STATE OF MAINE
DEPARTMENT OF TRANSPORTATION
16 STATE HOUSE STATION
AUGUSTA, MAINE
04333-0016

December 28, 2006
Subject: **Topsham**
Pin No. 14062.11
Amendment No. 2

Work under this contract is generally described as the construction of the MaineDOT TOPSHAM HIGHWAY MAINTENANCE GARAGE

TITLE
BUILDING RADIANT HEAT
BOILER ROOM DETAILS

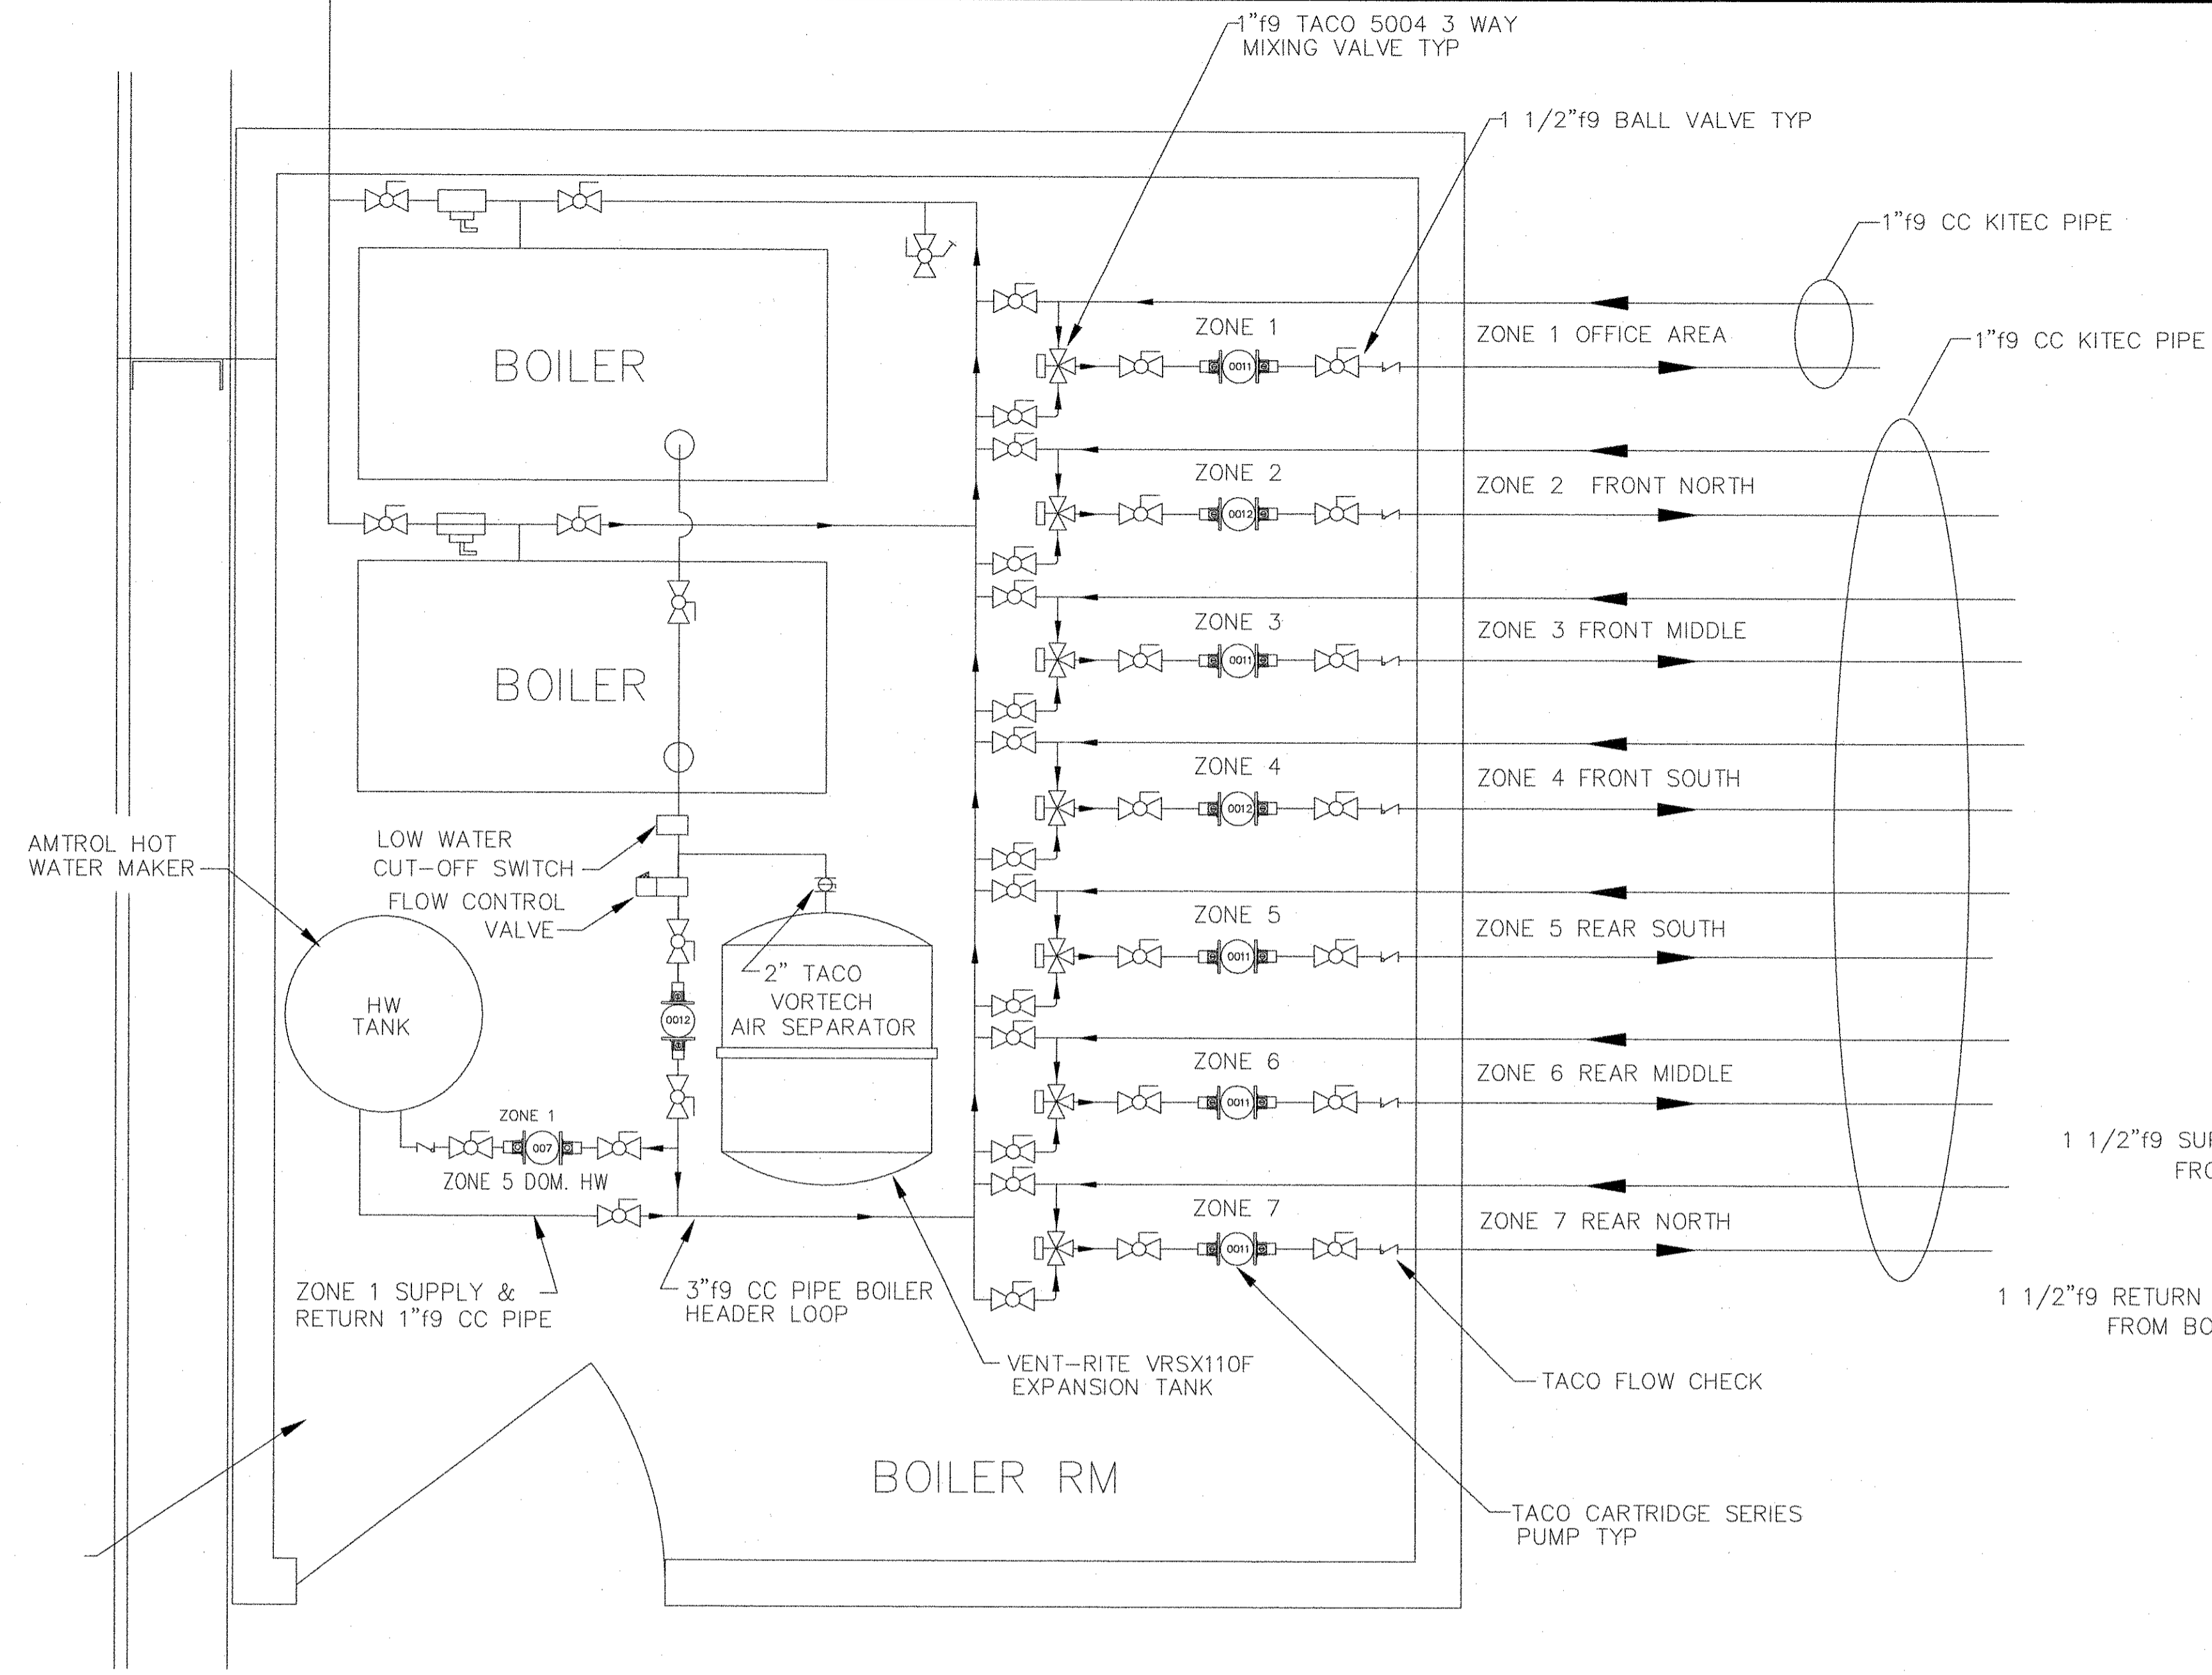
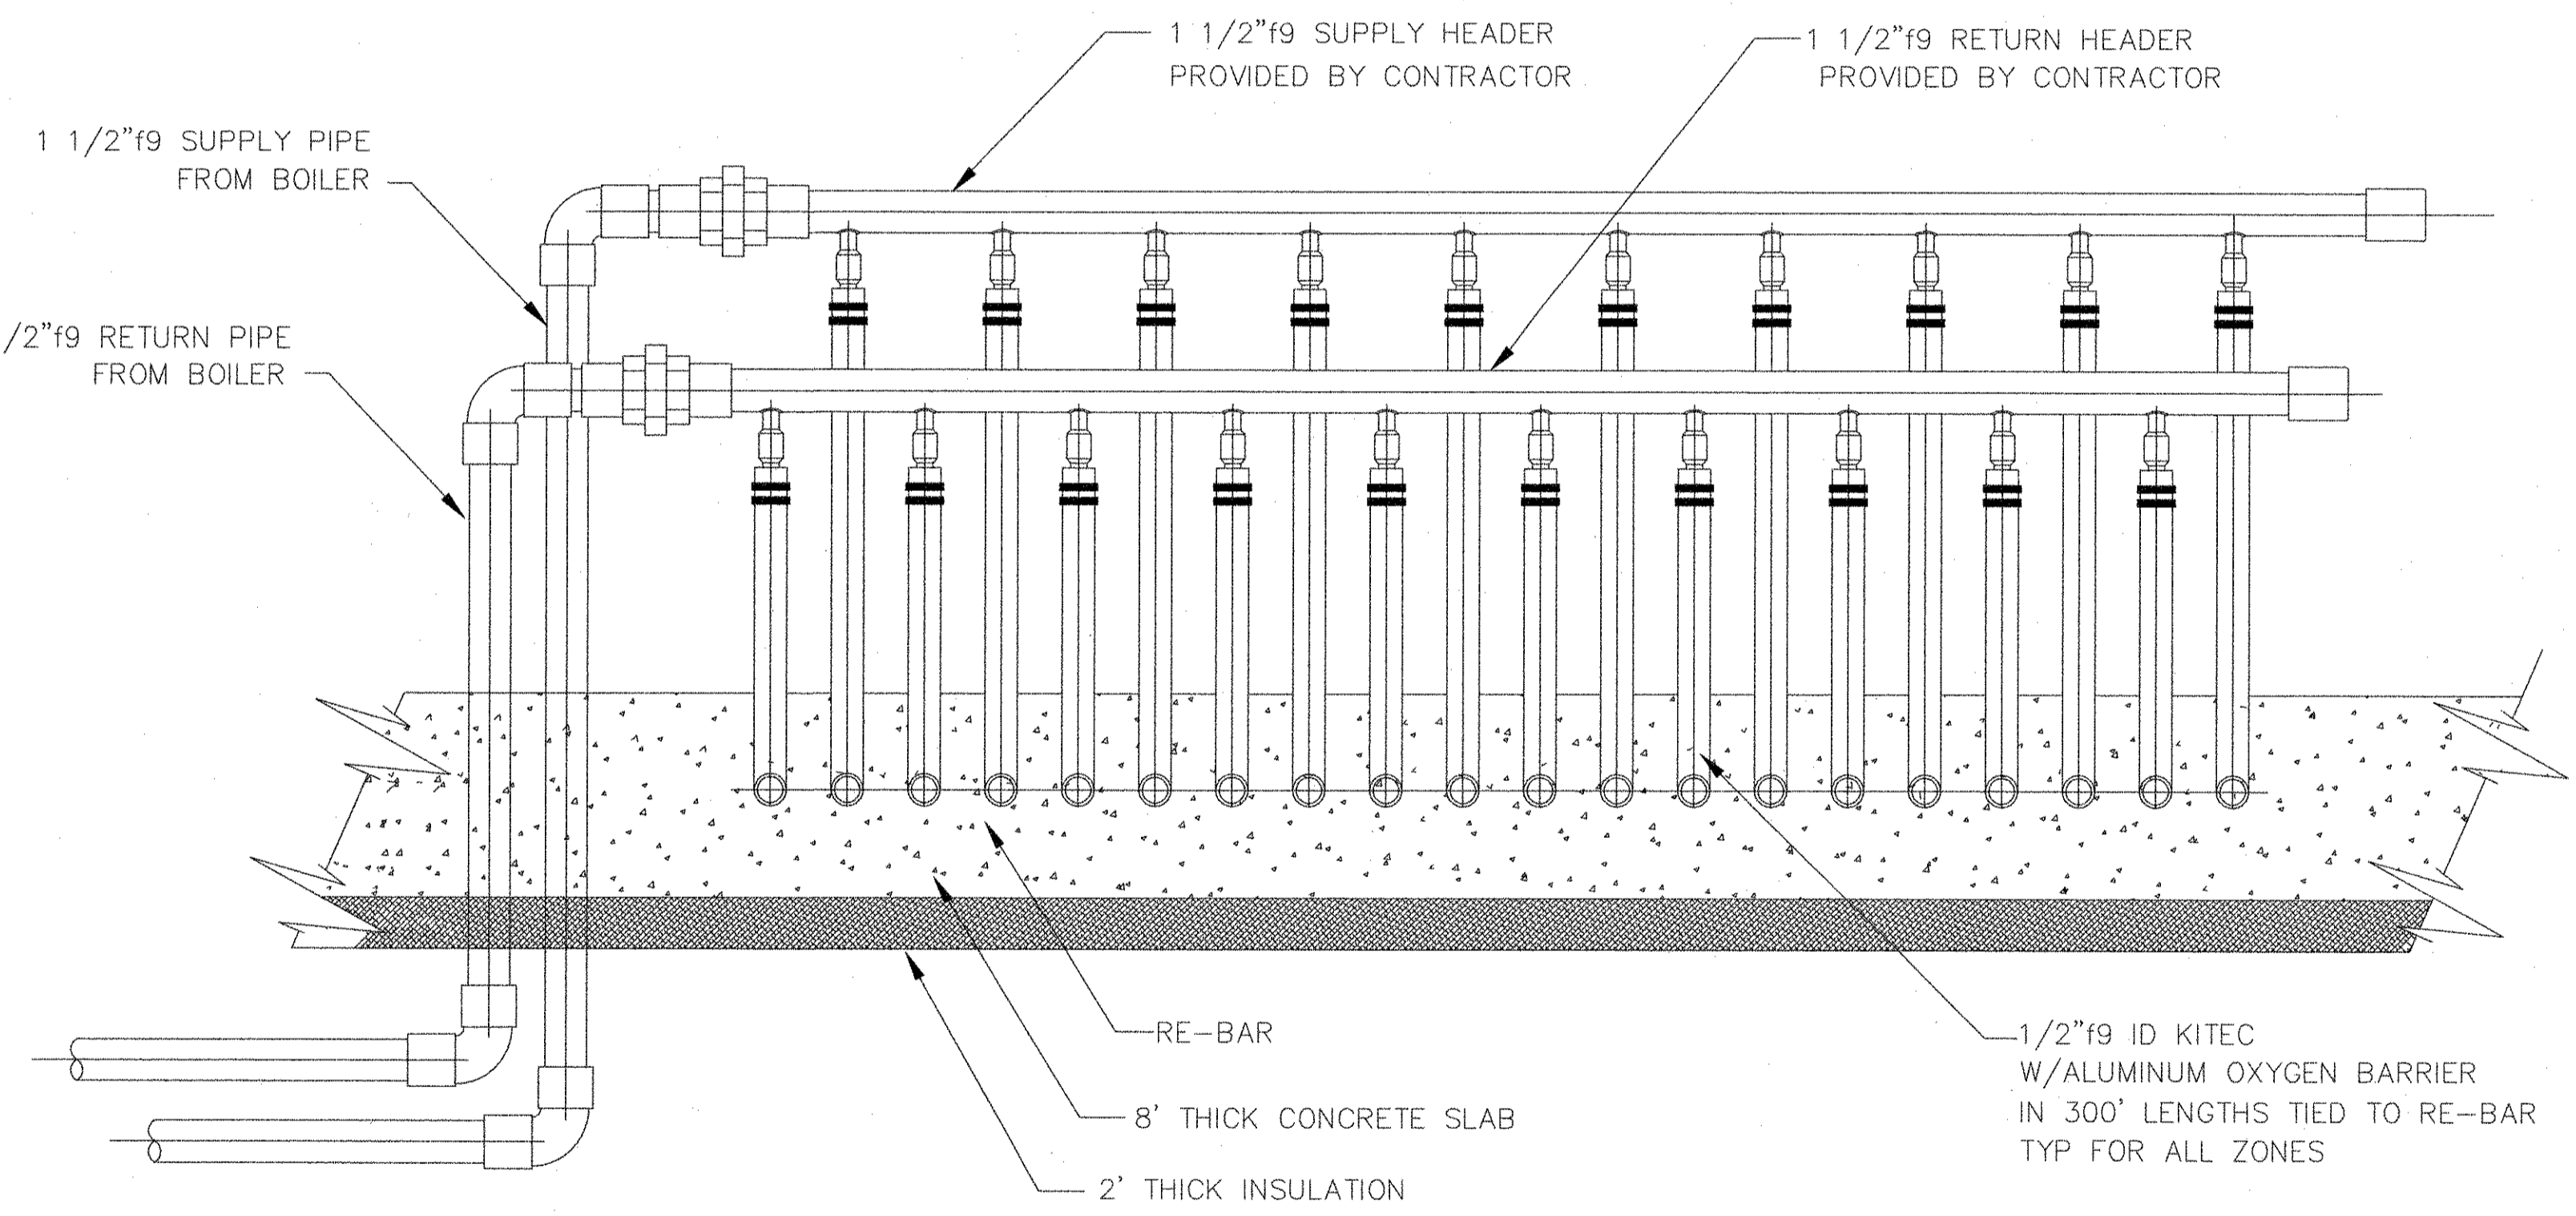
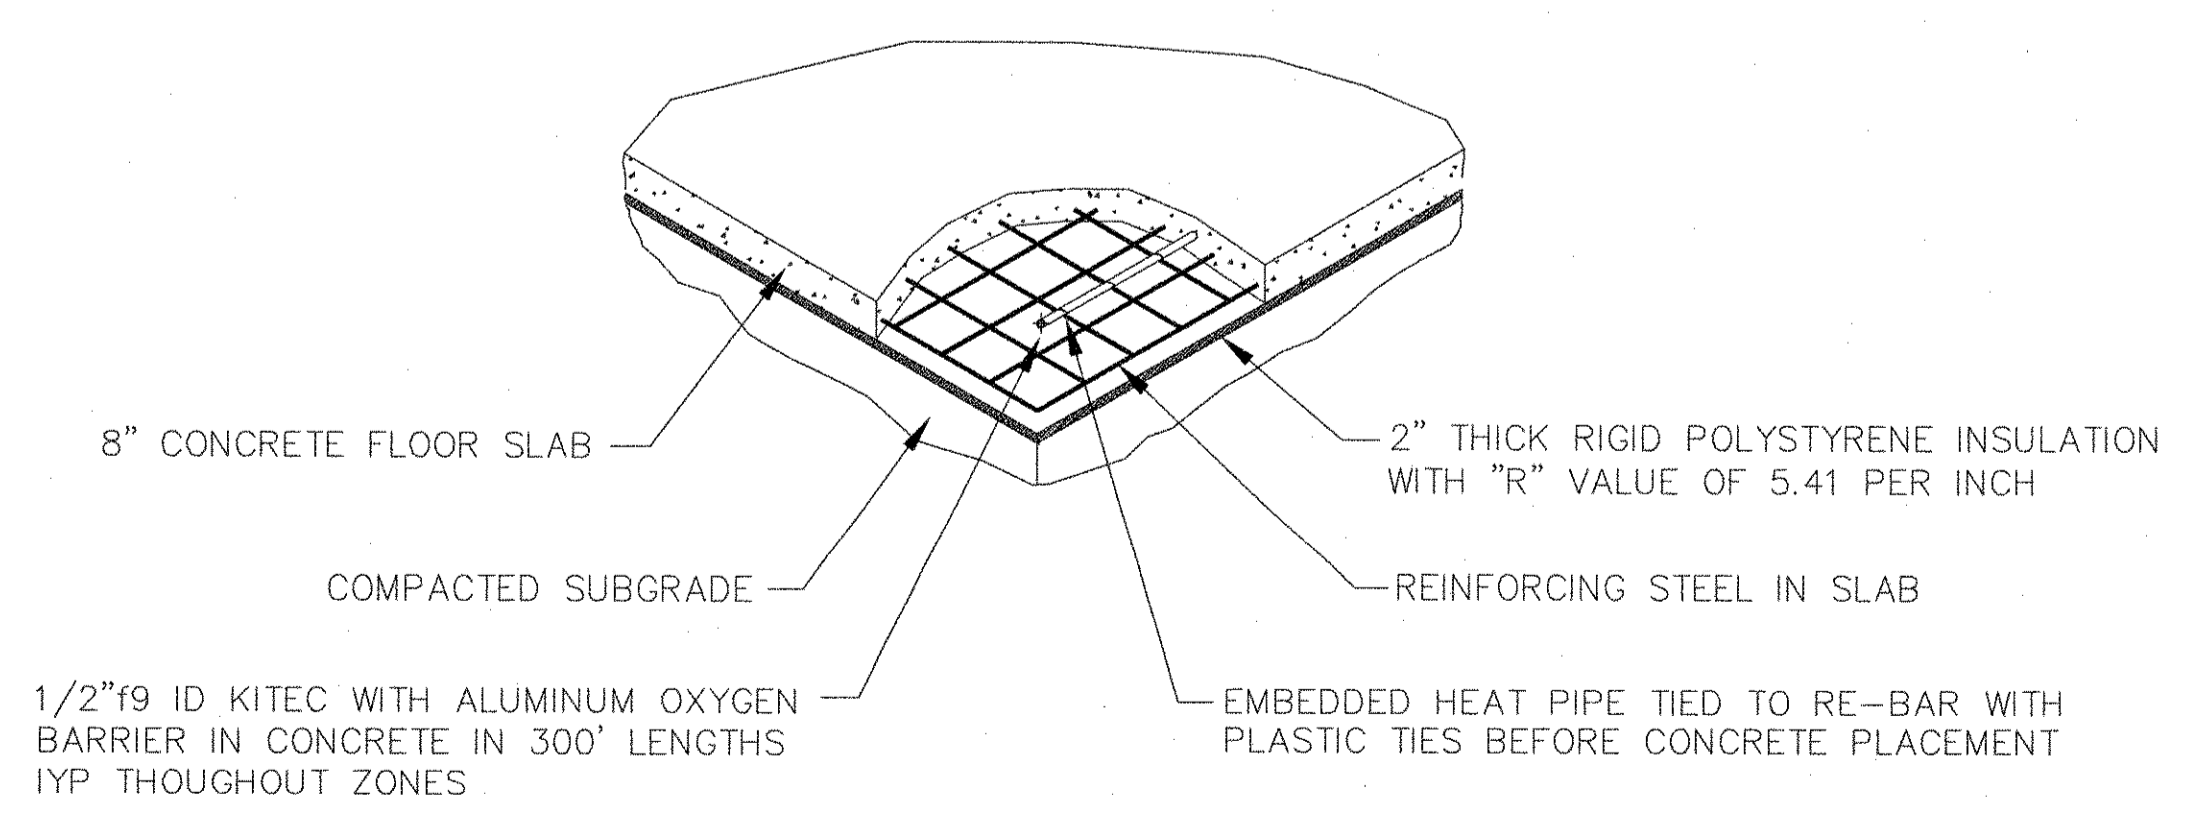
On plan sheet "H-6, Building Radiant Heat Boiler Room Details" under "Notes" DELETE in its entirety Note 2 that begins "All dom. Cold water..." and REPLACE with the new updated Note 2 that reads: "All Dom. Cold water and heat pipes are to be insulated with Armaflex Insulation, minimum ½" thickness ." Make this change in pen and ink.

Question: H-6 notes to use Type M copper for Domestic Hot Water and Boiler Feed while spec 15001 notes to use Type L only.

Question: There is no mention of pipe insulation thickness.

Response: H-6 is correct. Use Type M copper for Domestic Hot Water and Boiler Feed. In Division 15, Mechanical, under Section 15001 Water System, sub-section 2.2A has been replaced with the new updated sub-section 2.1 A earlier in this amendment.

Response: On plan sheet "H-6, Building Radiant Heat Boiler Room Details" under "Notes", Note 2 has been replaced to read: "... minimum 1/2" thickness."
